**Ferret  
Exploration  
Company of  
Nebraska, Inc.**

March 28, 1988

Enclosed please find corrected replacement pages for the Application and Supporting Environmental Report for USNRC Commercial Source Material License. Please replace the original pages with the corrected pages. These changes were made as a result of the NDEC completeness Review.

ERRATA SHEET  
DEC Completeness Review

Figure 4.9(B)-1

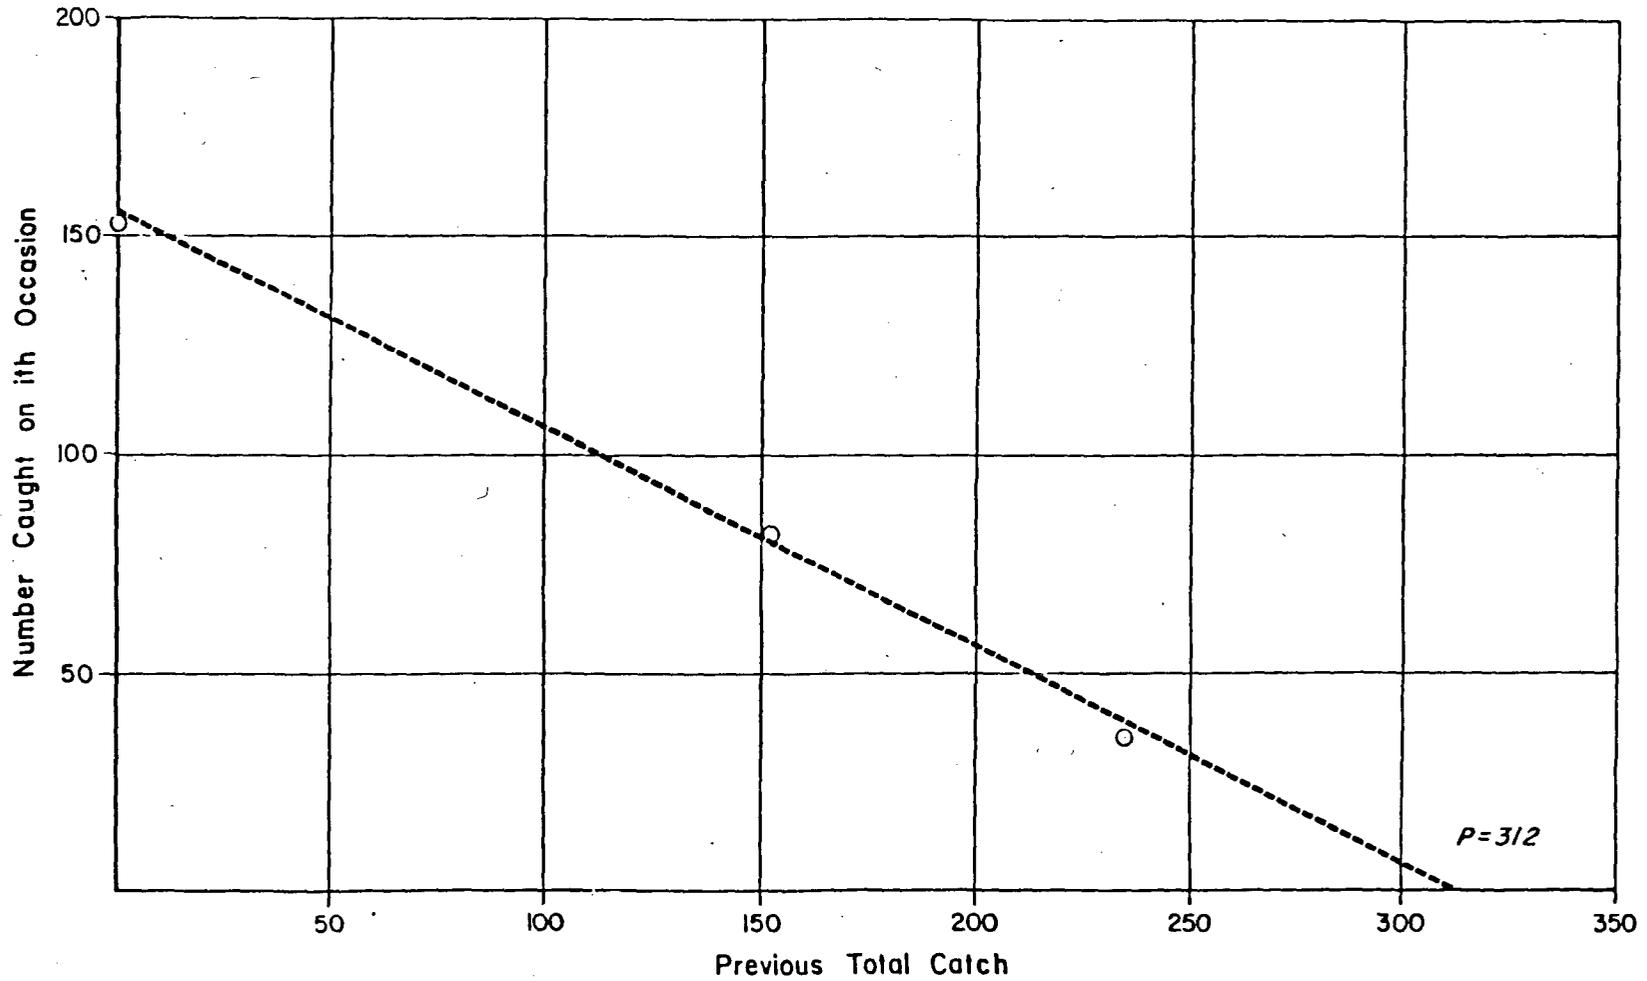
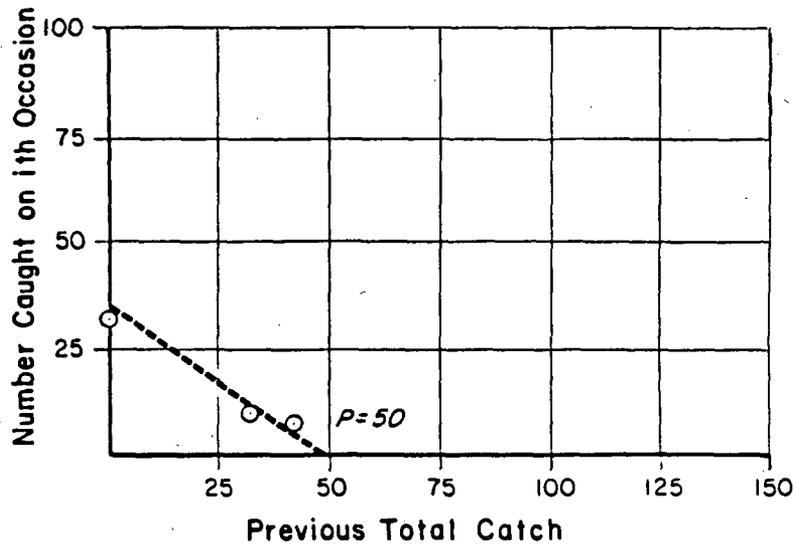
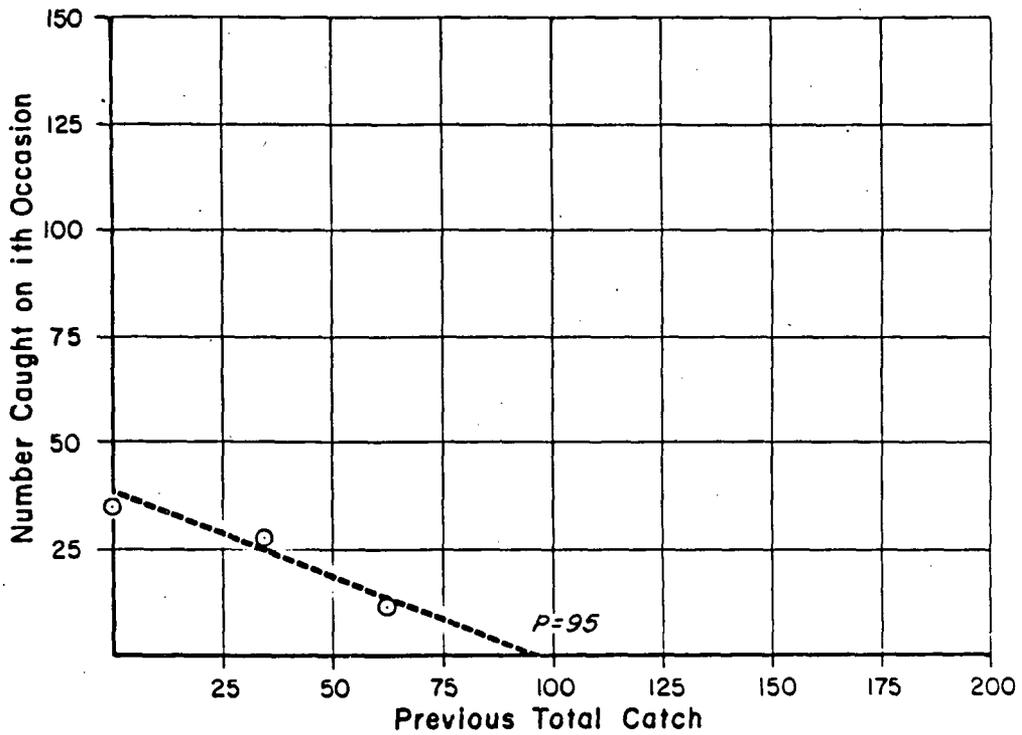
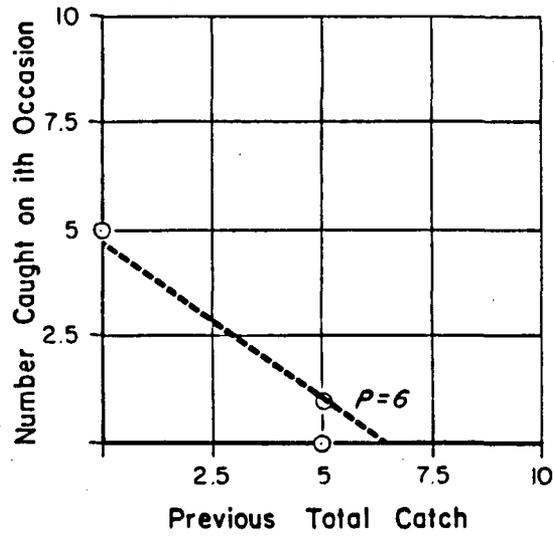
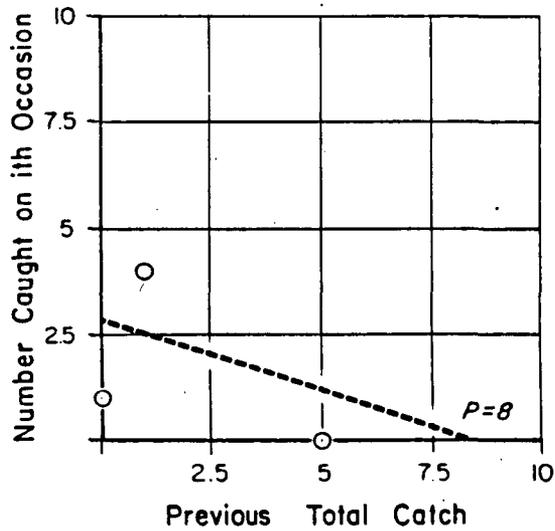
1. Fish population estimate data collected at Stations W-1 and W-3 on November 2, 1983, have not been included in the application. At the top of Page 4.9(113), the fish population estimate data collected on November 2, 1983, is stated to be in Appendix 4.9(B) of the application. Appendix 4.9(B) needs to be added to the application.

Appendix 4.9(B) has been included to be added to the permit application.

REV	BY	DATE	FERRET OF NEBRASKA, INC.	
1	BC	2/16/88	CROW BUTTE PROJECT	
			Dawes County, Nebraska	
			Typical Liner Completion for	
			Monitor or Injection/Production Wells	
			PREPARED BY: F.E.N.	
			DWN BY: J.C.	DATE: 8/87
				FIG. 10.2-2

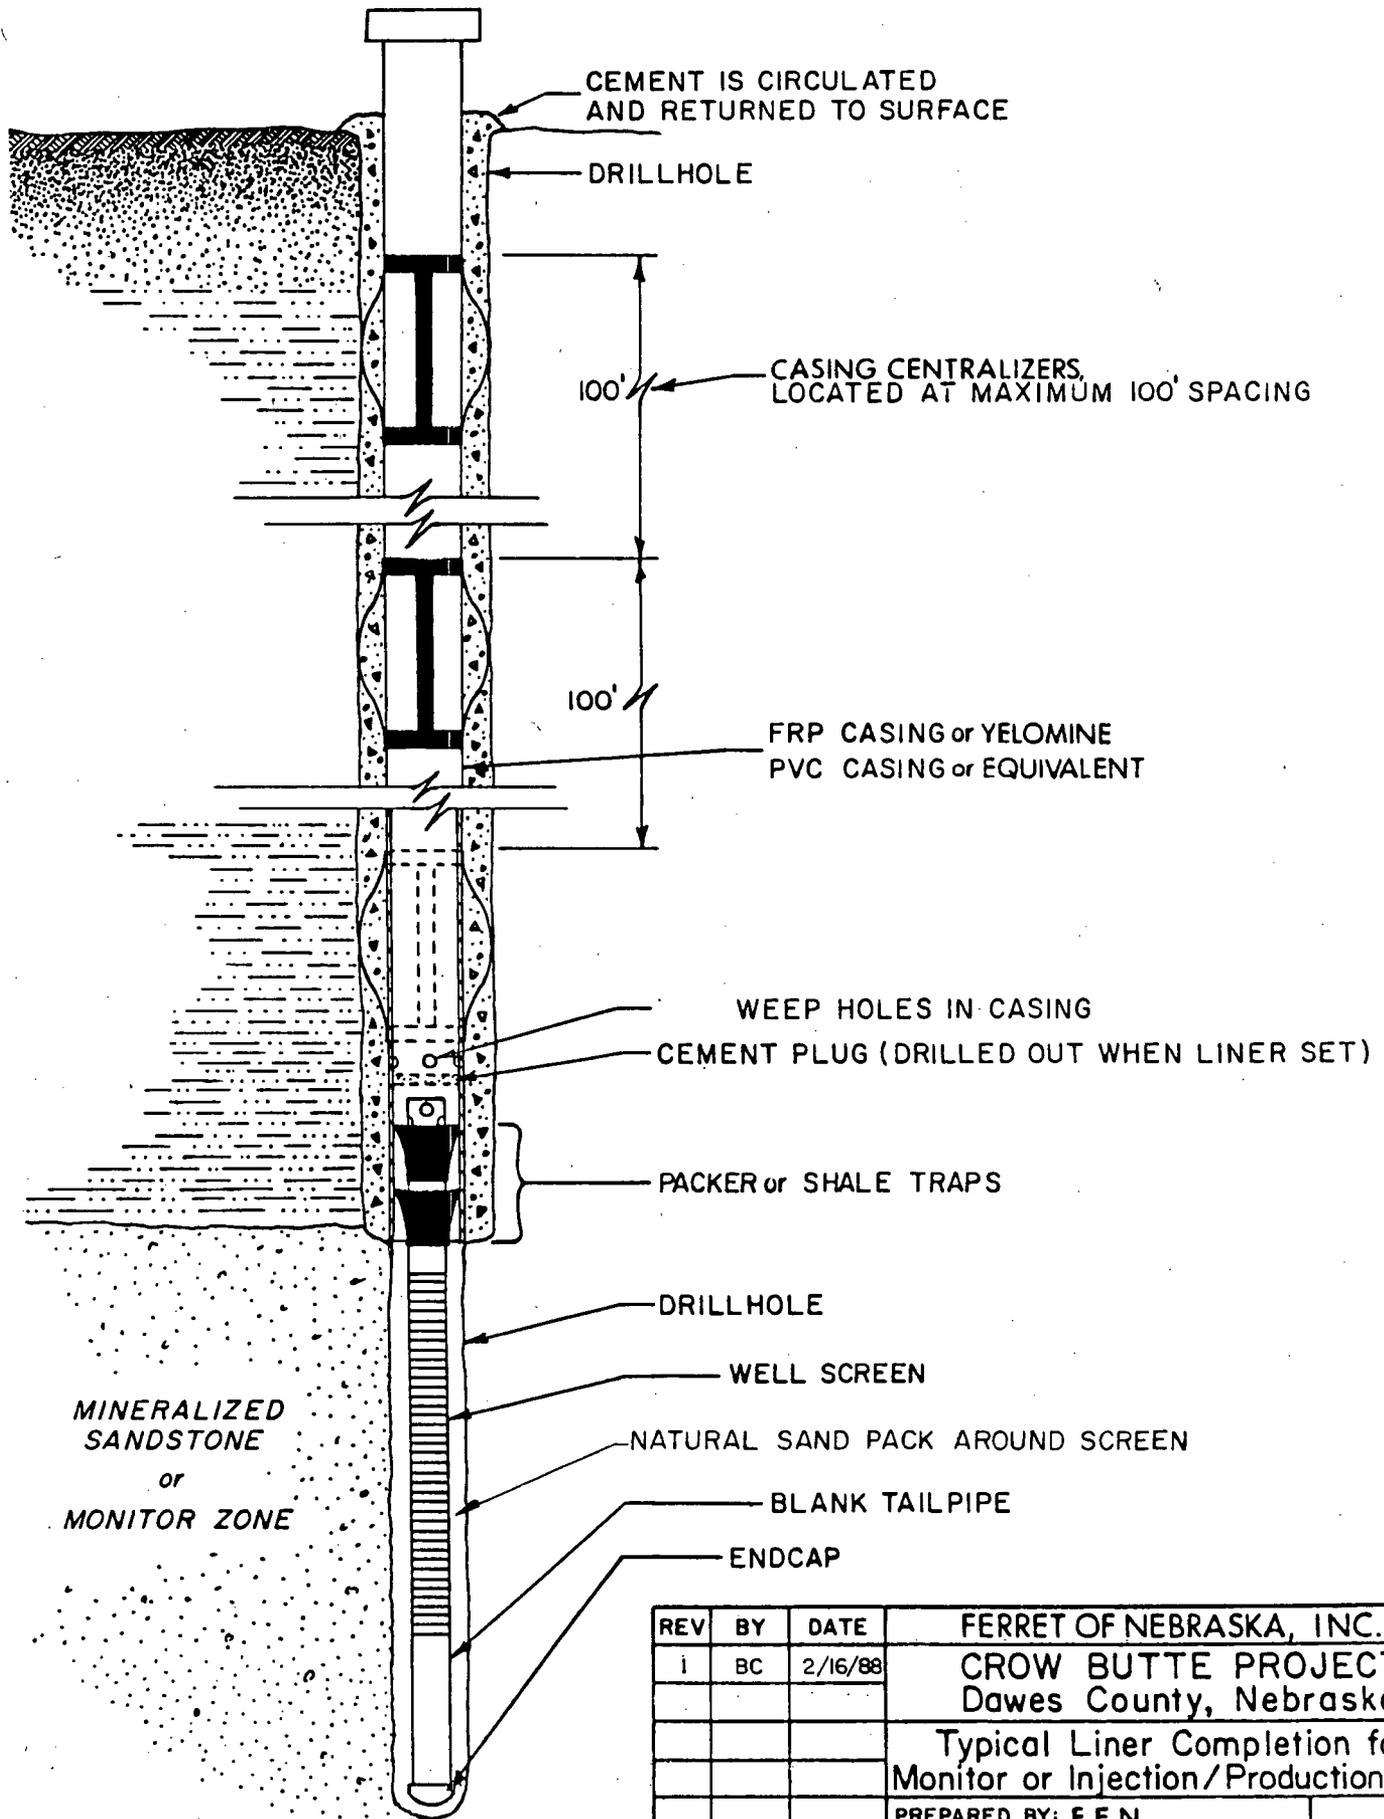
p.11.0(2), para 1: If selective screening of sandstone intervals, between clay beds, is planned, it will be of no use without a sand pack through sandstone intervals and bentonite through clay intervals (See comments for p.10.0(1) to 10.0(4) above).

This is natural sand packing that is developed during well clean-up. A clarification has been added to the text in 8.0 and on the Figures 10.2-1 and 10.2-2.
